Proposed\_Level Roof  
 1 : 50

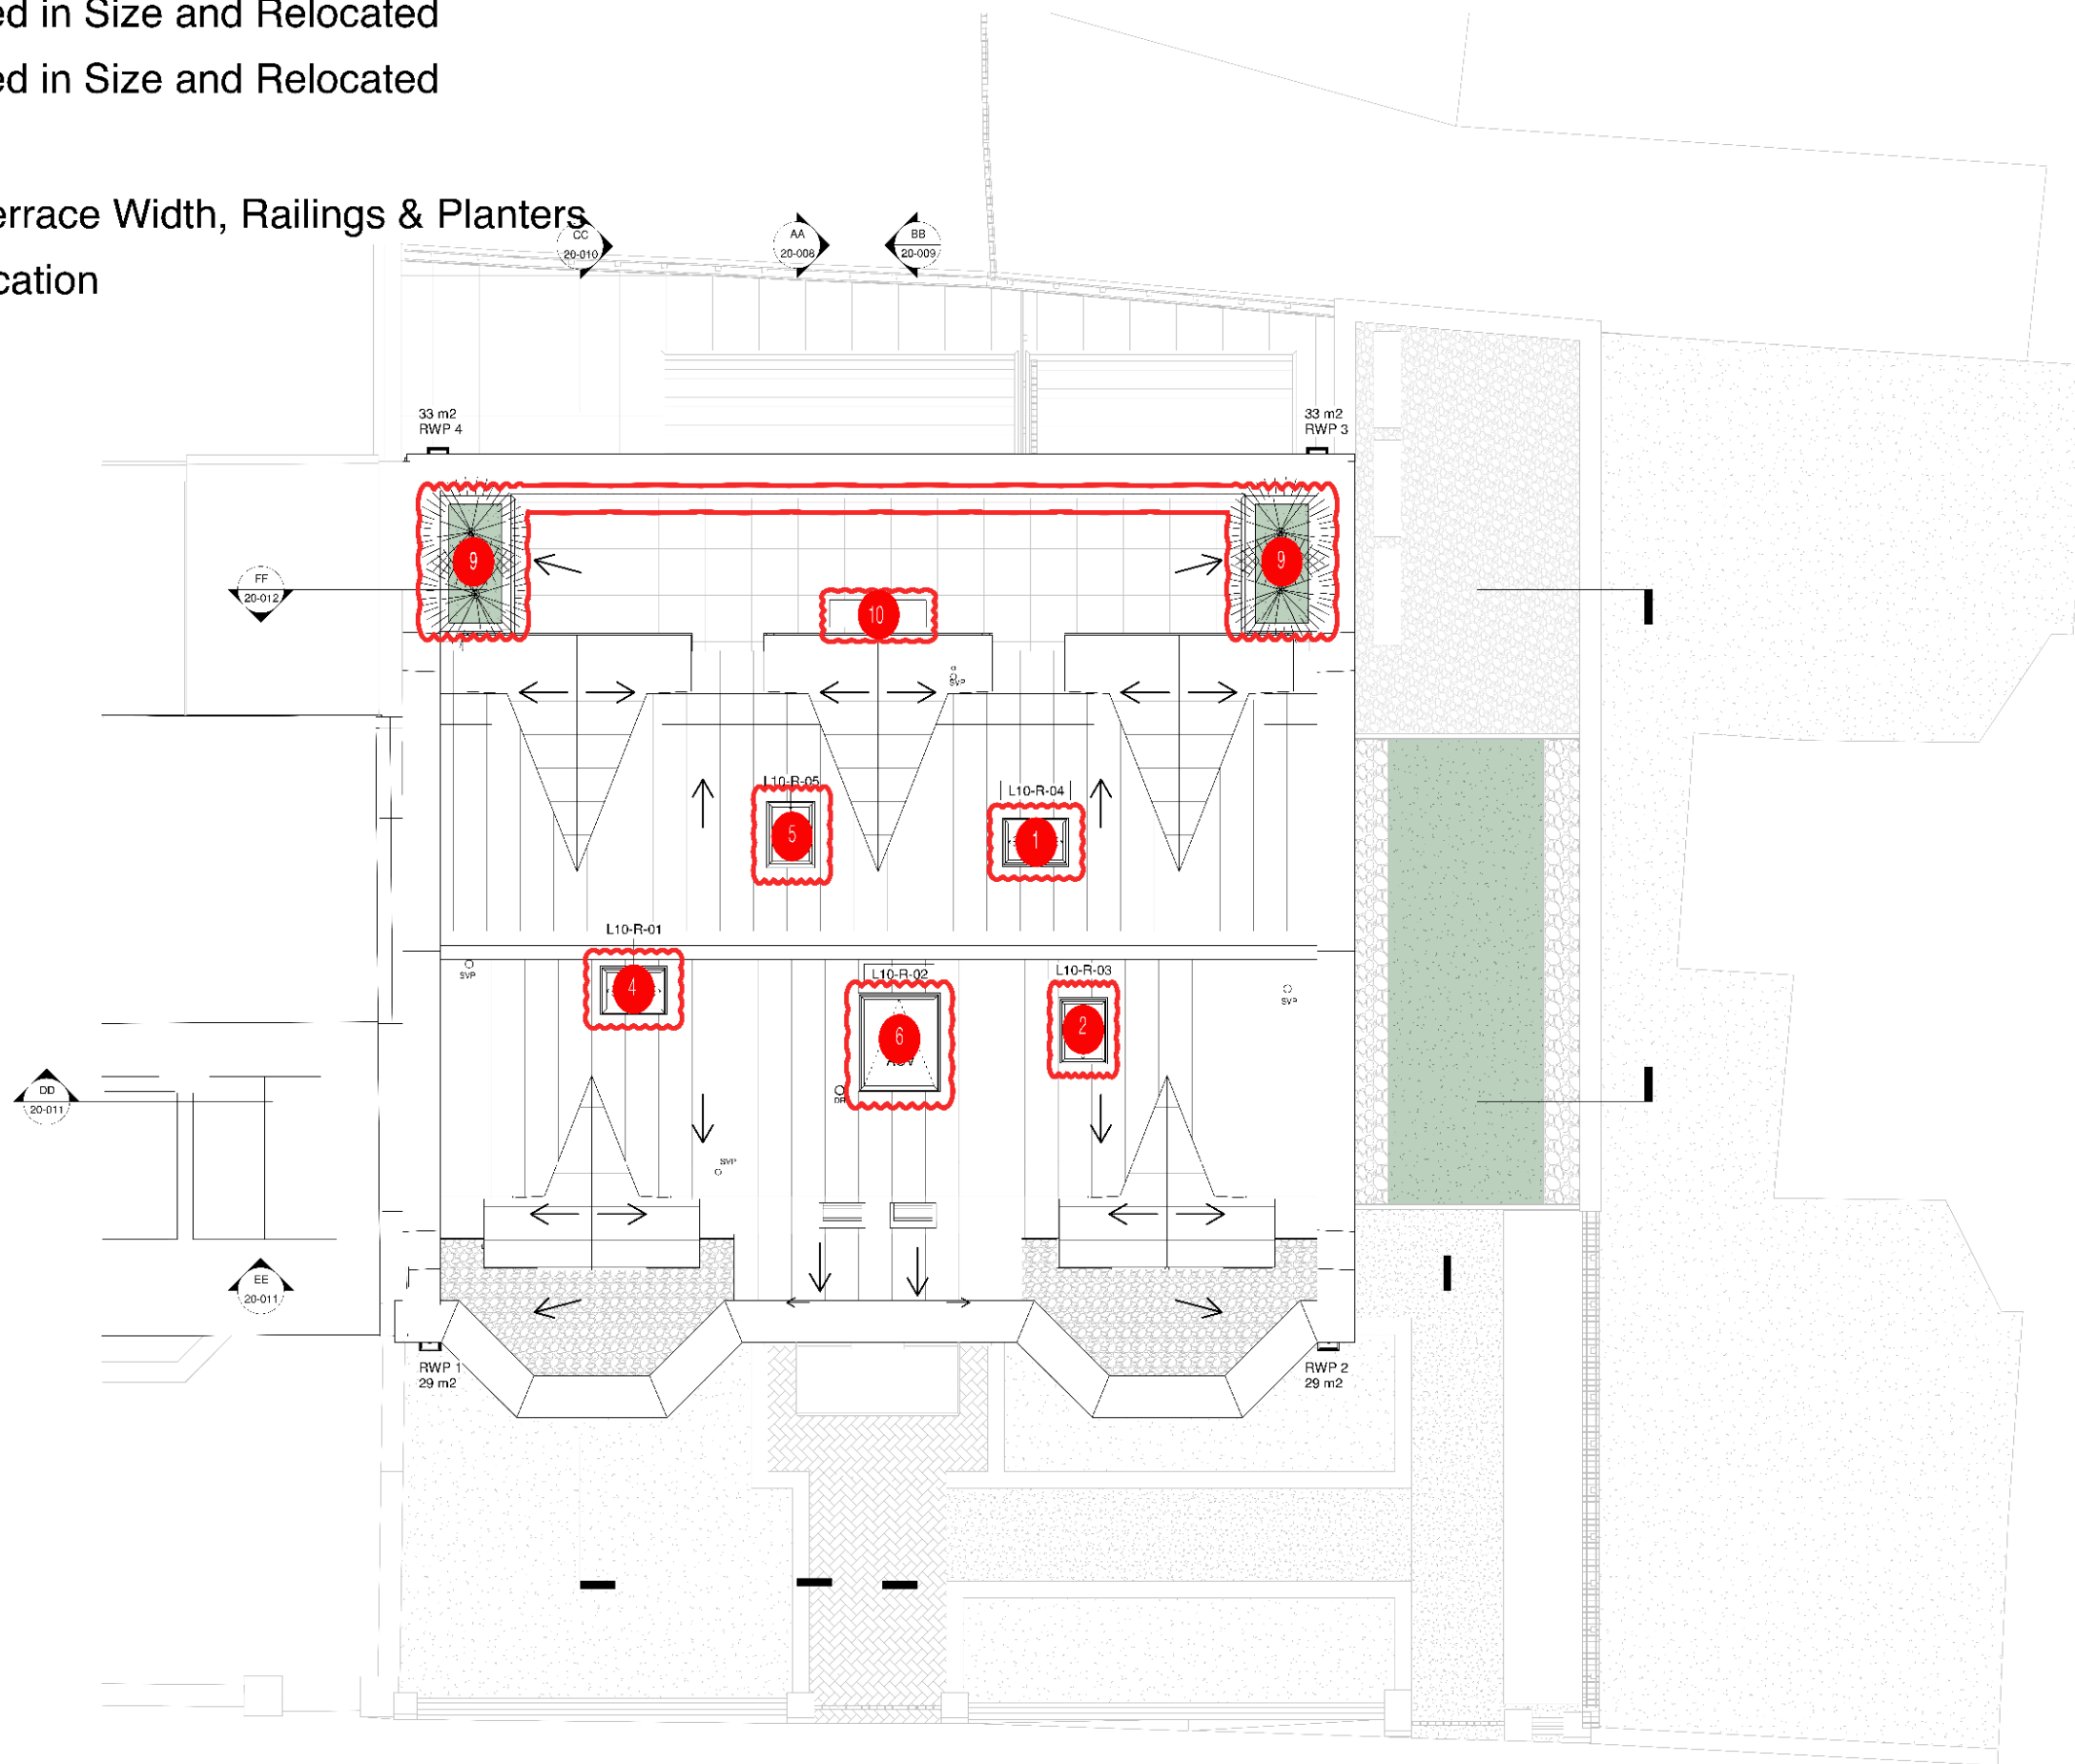
- 1 Roof Light Reduced in Size and Relocated
- 2 Roof Light Reduced in Size and Relocated
- 4 Roof Light Reduced in Size and Relocated
- 5 Roof Light Reduced in Size and Relocated
- 6 Inclusion of AOV
- 9 Change to Roof Terrace Width, Railings & Planters
- 10 Unit 7 ASHP Relocation
